From: [Brian Moench](#)
To: [Wren, Kira](#)
Cc: [John Collins](#); [Kris Thompson](#)
Subject: RE: #57-008 Copy of Notice of Violation and Proposed Agreed Order. GFL Solid Waste Midwest LLC. Case No. 2023-29526-S.
Date: Wednesday, June 26, 2024 5:21:44 PM
Attachments: [image002.png](#)
[image003.png](#)
[image004.png](#)
[image005.png](#)
[image006.png](#)
[image007.png](#)
[image008.png](#)
[image009.png](#)
[image011.png](#)
[image012.png](#)
[image001.png](#)
[21312 A-Plot-Existing Building As-Built A101 06-26-24.pdf](#)
[21312 C-Plot All ASB-C201 6-26-24.pdf](#)

Bunn Box, Inc. - Transfer Station
 2164 Production Road
 Kendallville, Indiana 46755
 Wayne Township - Noble County
SITE PLAN - AS-BUILT

Bunn Box, Inc. - Transfer Station
 2164 Production Road
 Kendallville, Indiana 46755
 Wayne Township - Noble County
FLOOR PLAN - AS BUILT

A101 - AB

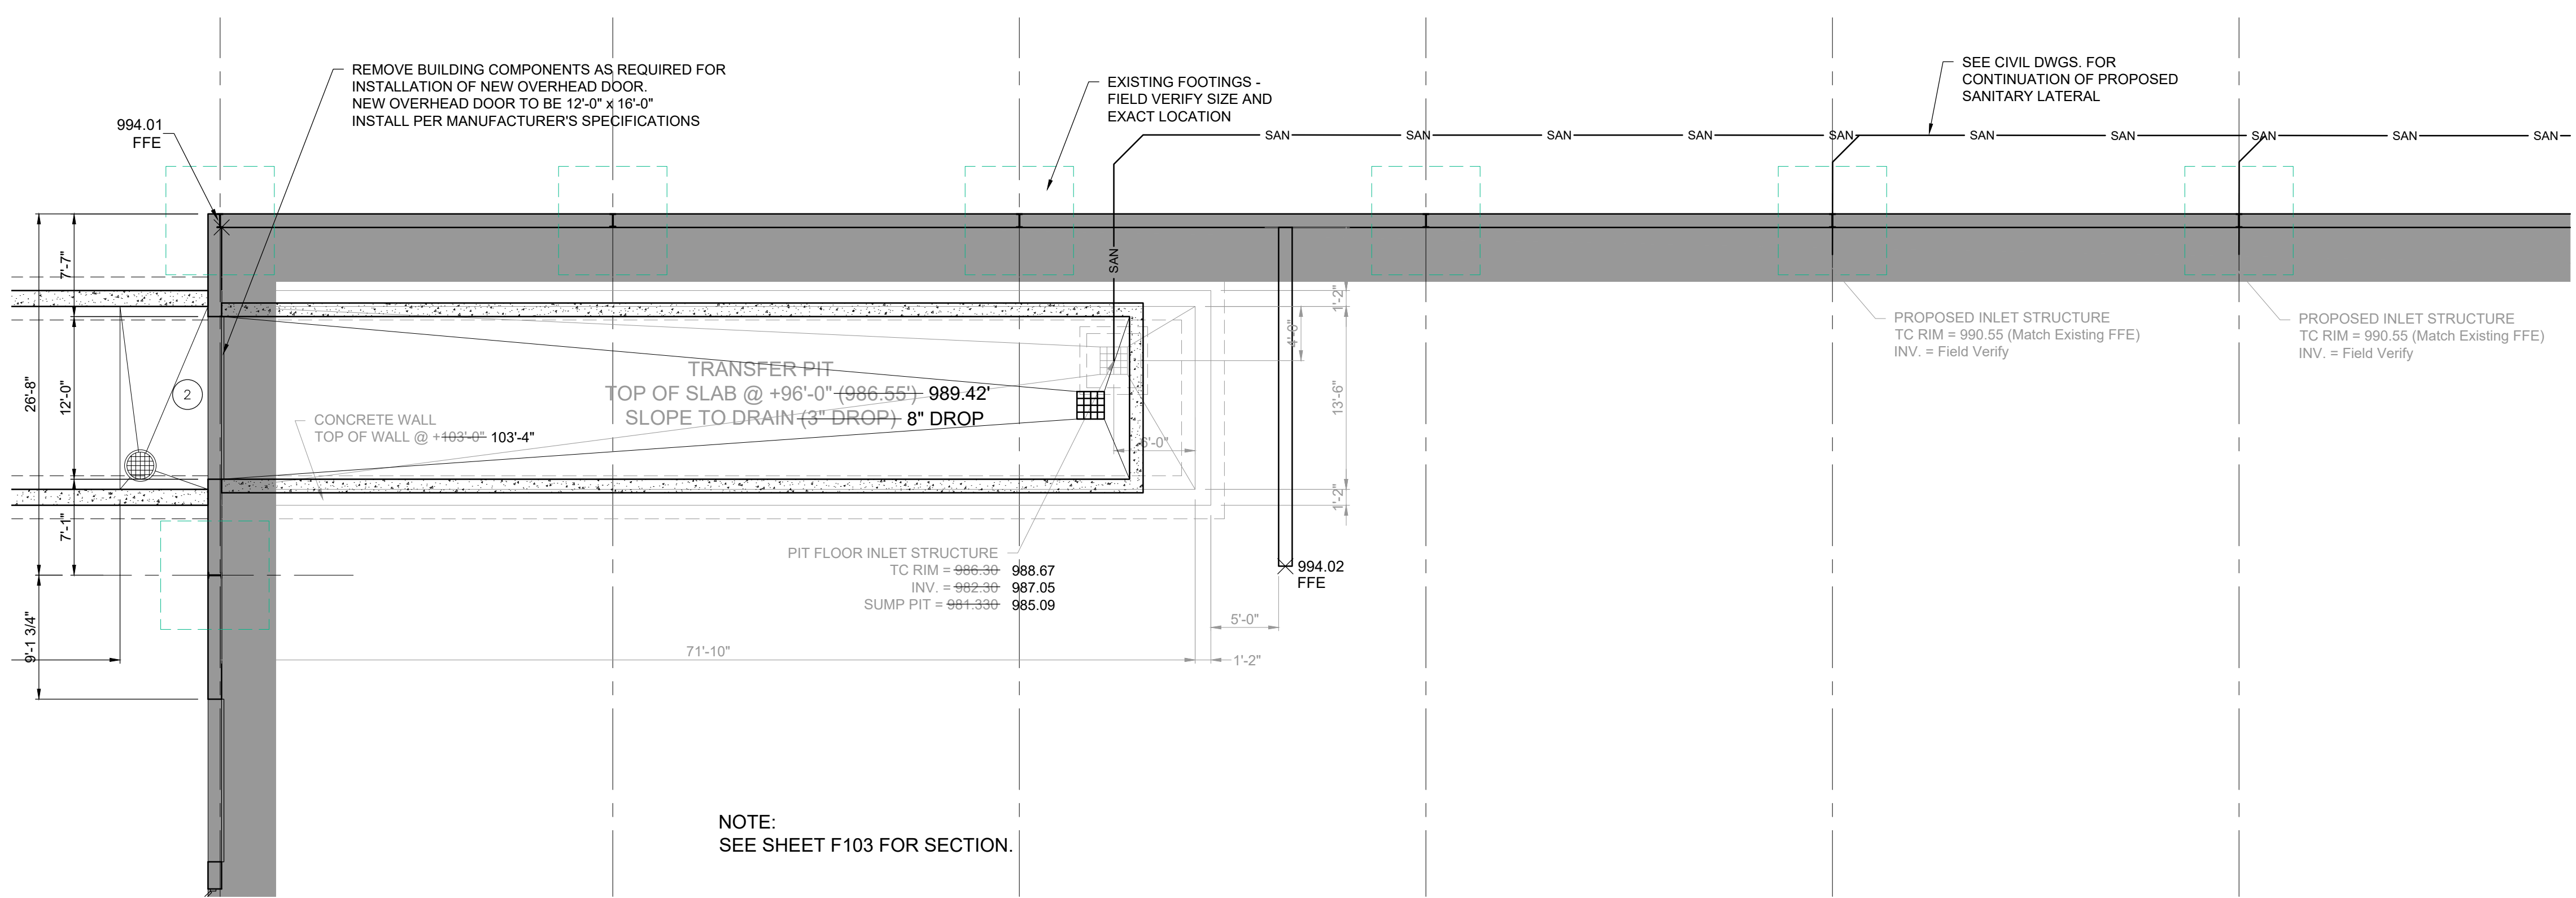
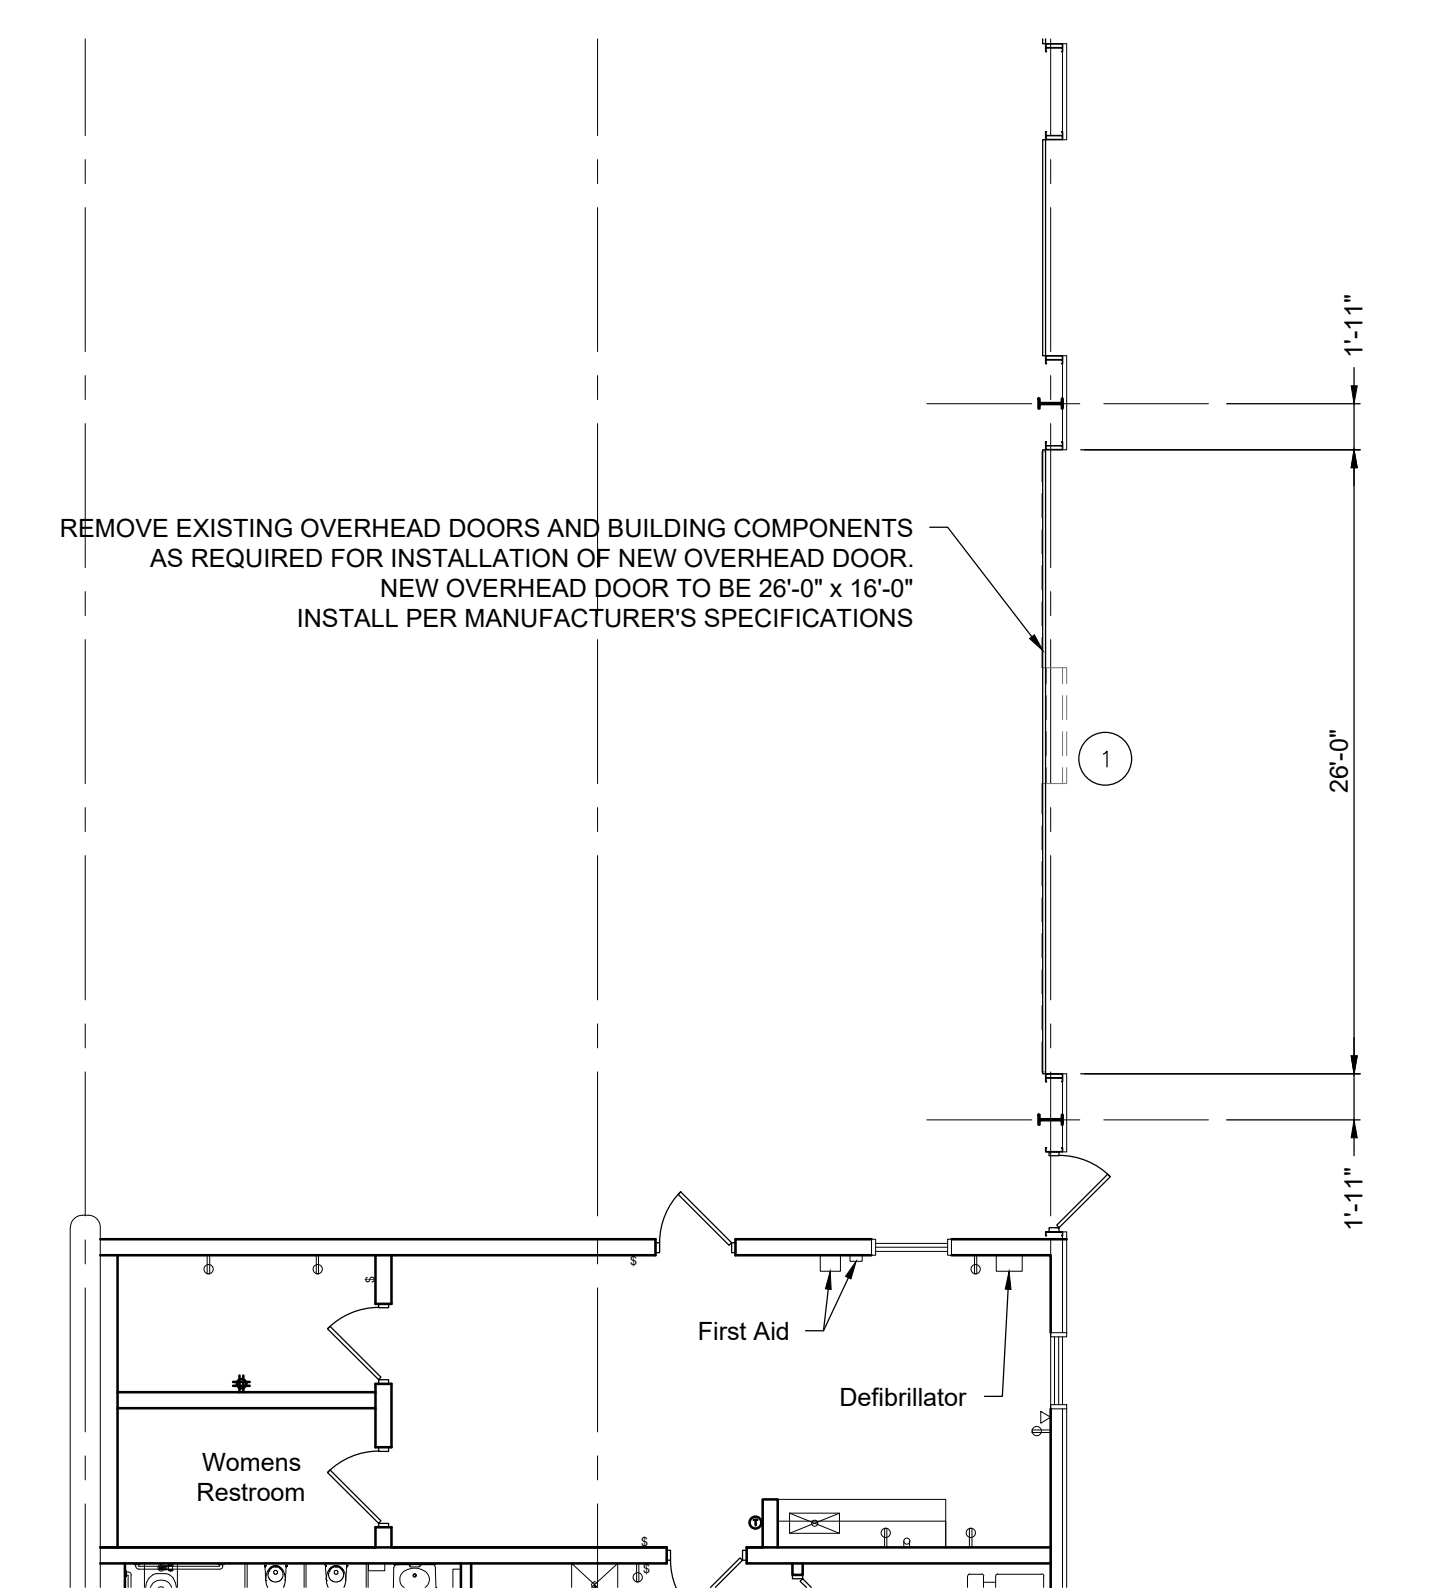
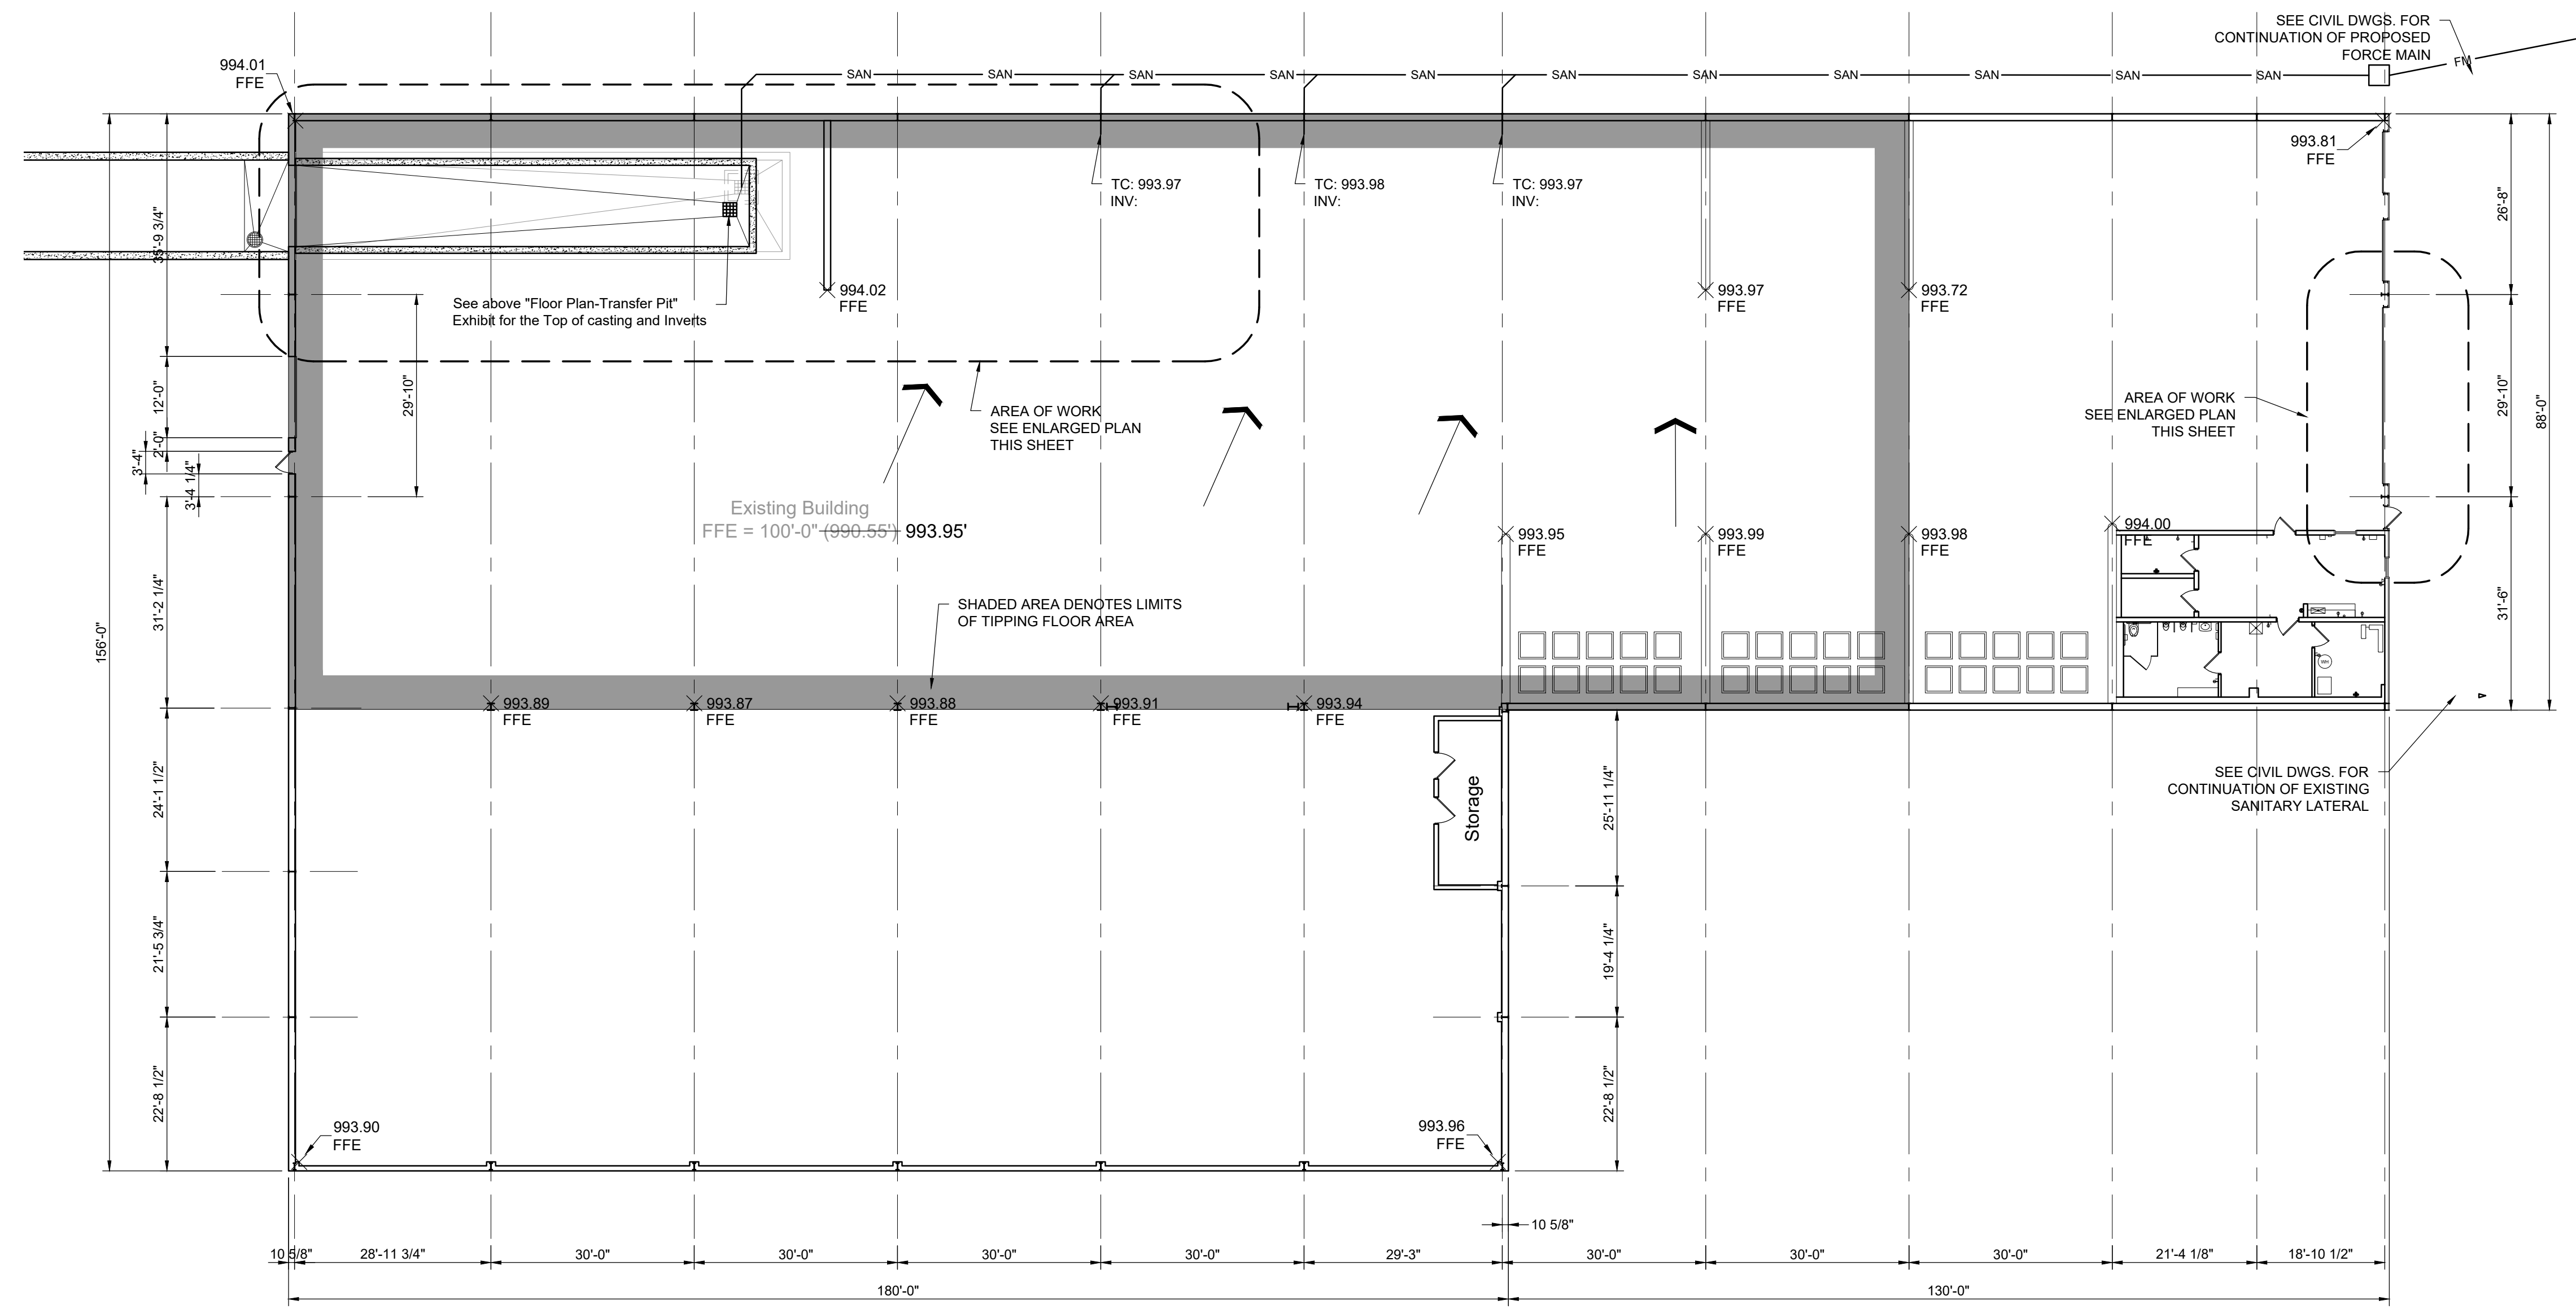
- Removal of west bounding wall in the temporary storage area,
- Elevations of each corner of the waste processing areas (existing concrete floor),
- Slope breaks in the concrete floor,
- Pipe inverts and top of castings for the tipping floor inlet structures.
